LISTED BUILDING
CONSENT

Project Title:
107 High St, Lindfield, Haywards Heath, West Sussex, RH16 2HR

Drawing Title:
Fitted Wardrobes Joinery & Re-instated Door

Drawing No.:
5013

Proposed Scheme First Floor Plan
Scale 1:25@A1
1:50@A3

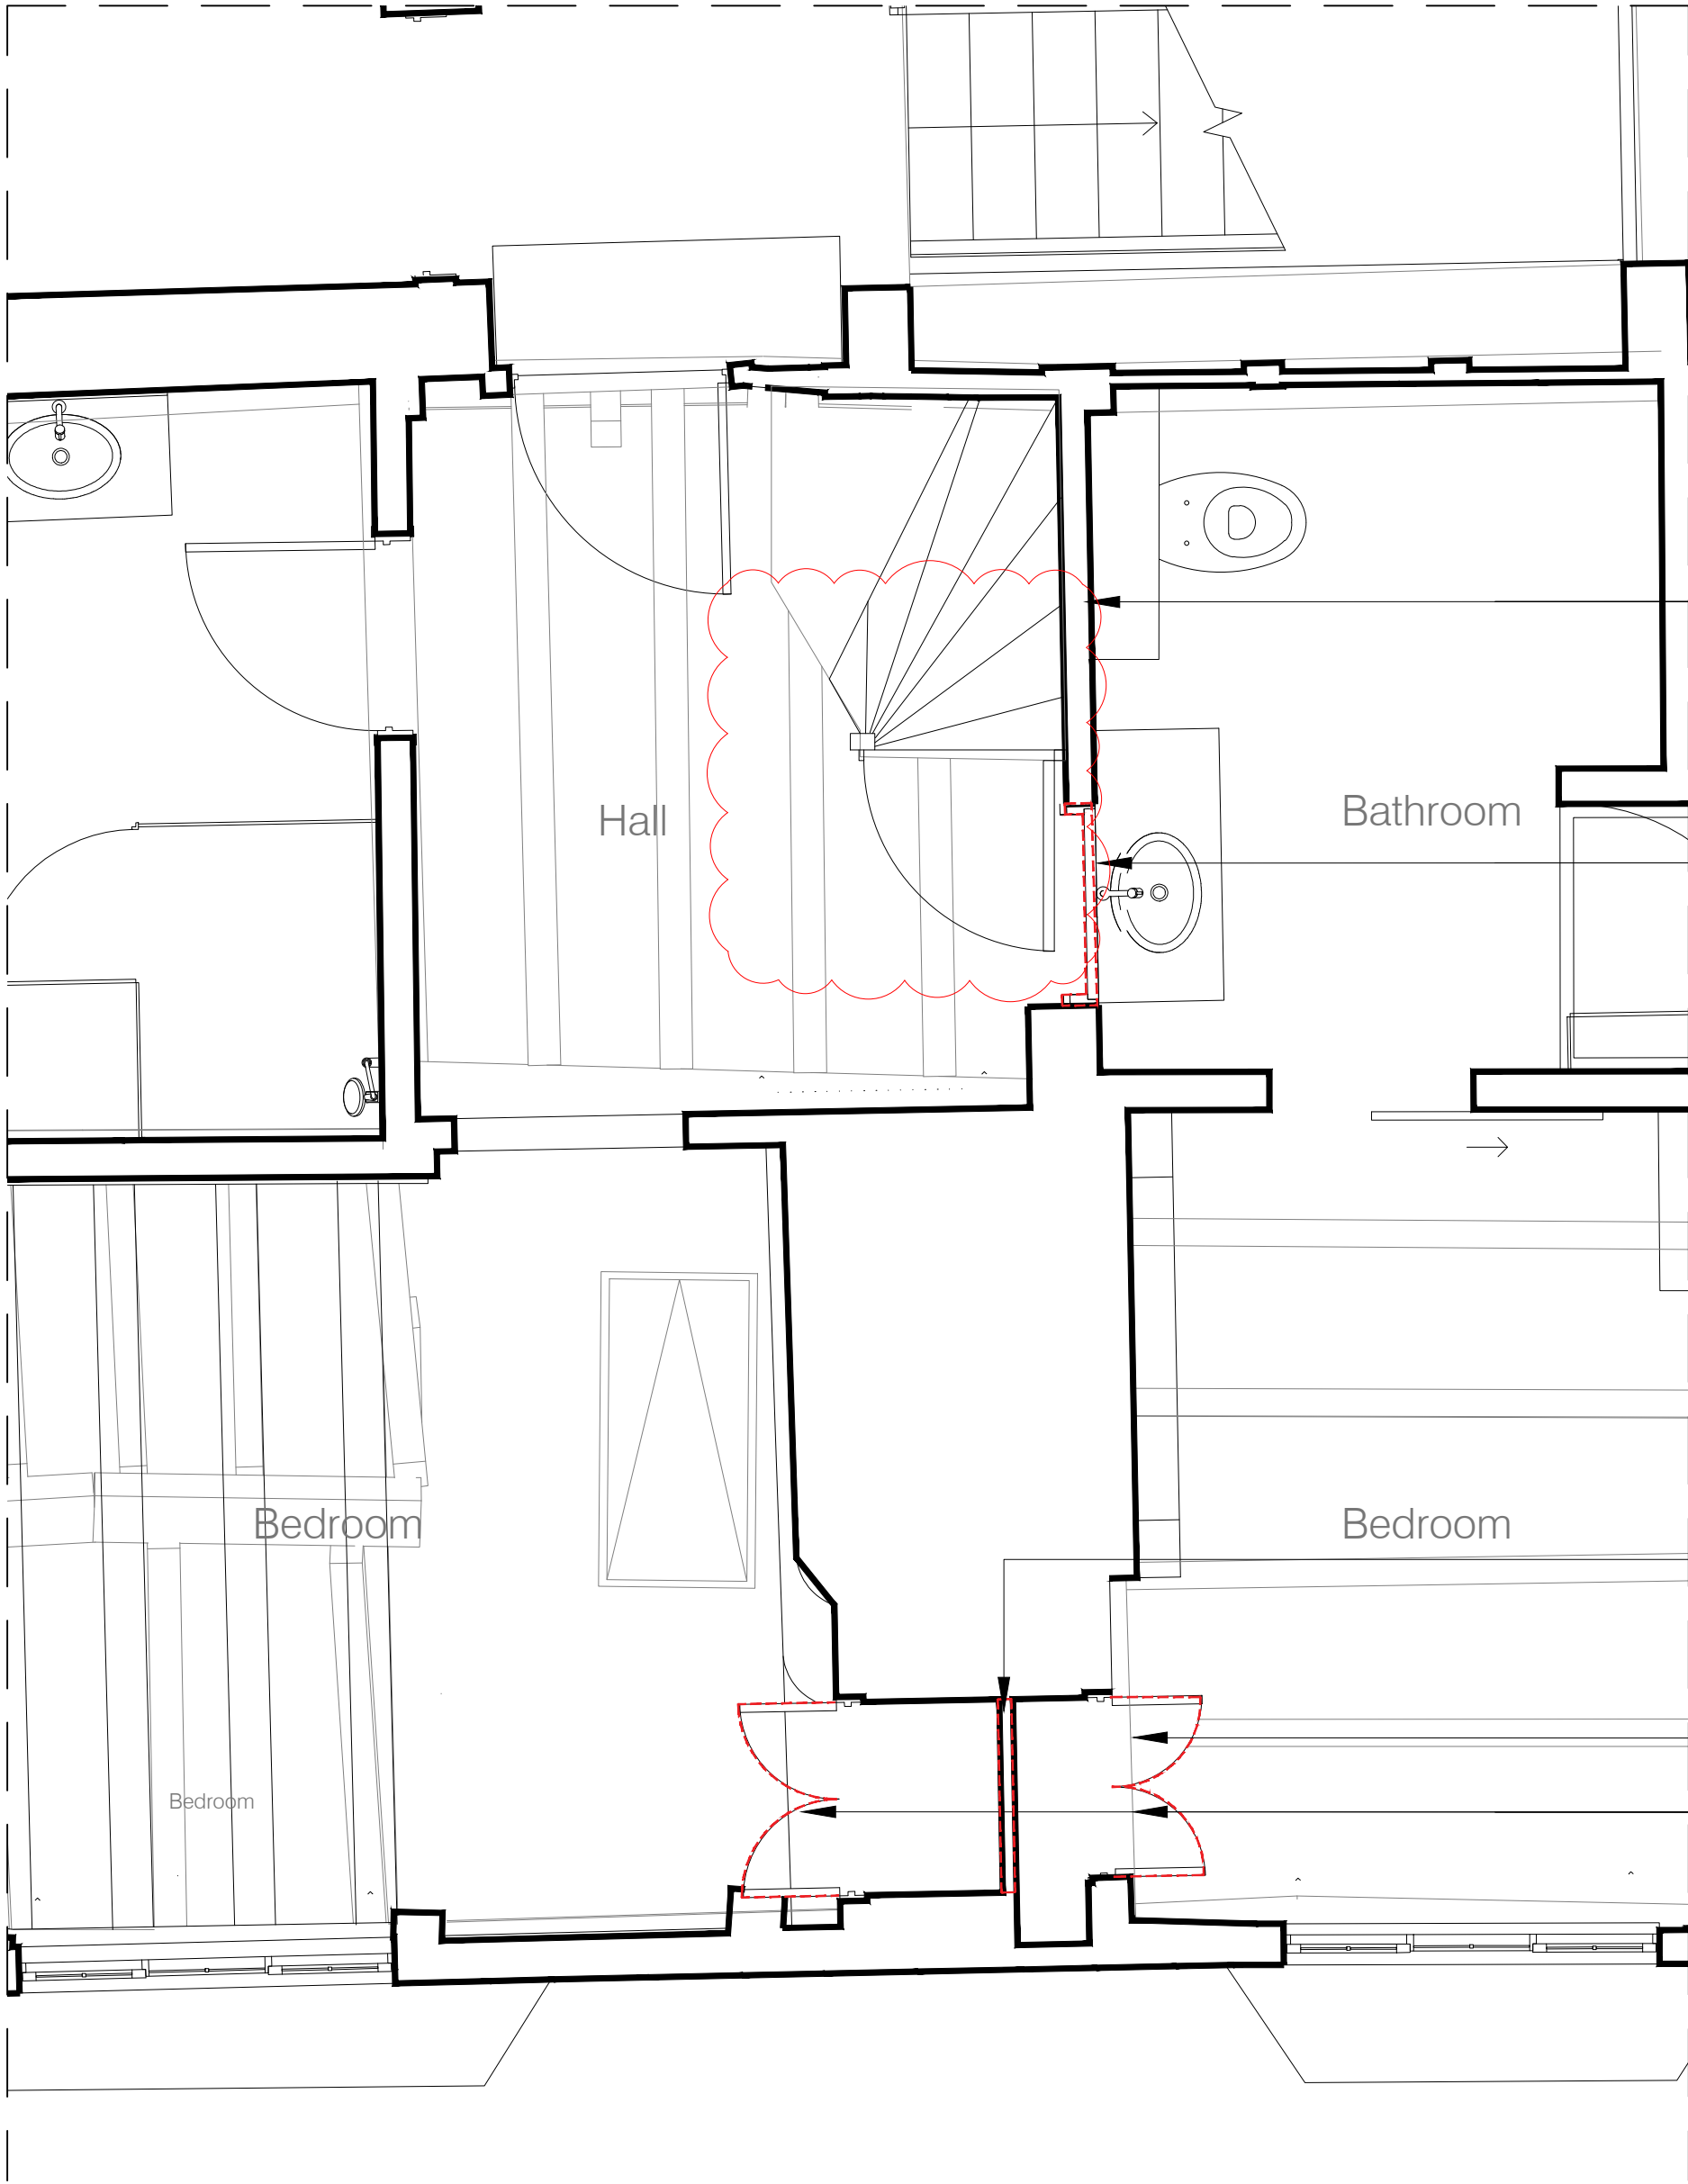
Opening in wall reinstated.
Existing door retained by the
Applicant to be reinstalled and
fixed shut to suit new en-suite
layout. Door to be exposed on
both sides.
Sink and vanity unit are
freestanding are removable.

Existing division reinstated

Existing door replaced

Fitted wardrobes joinery, 2no
18mm MDF back panels painted
off white

Existing timber door to be
re-instated and fixed shut
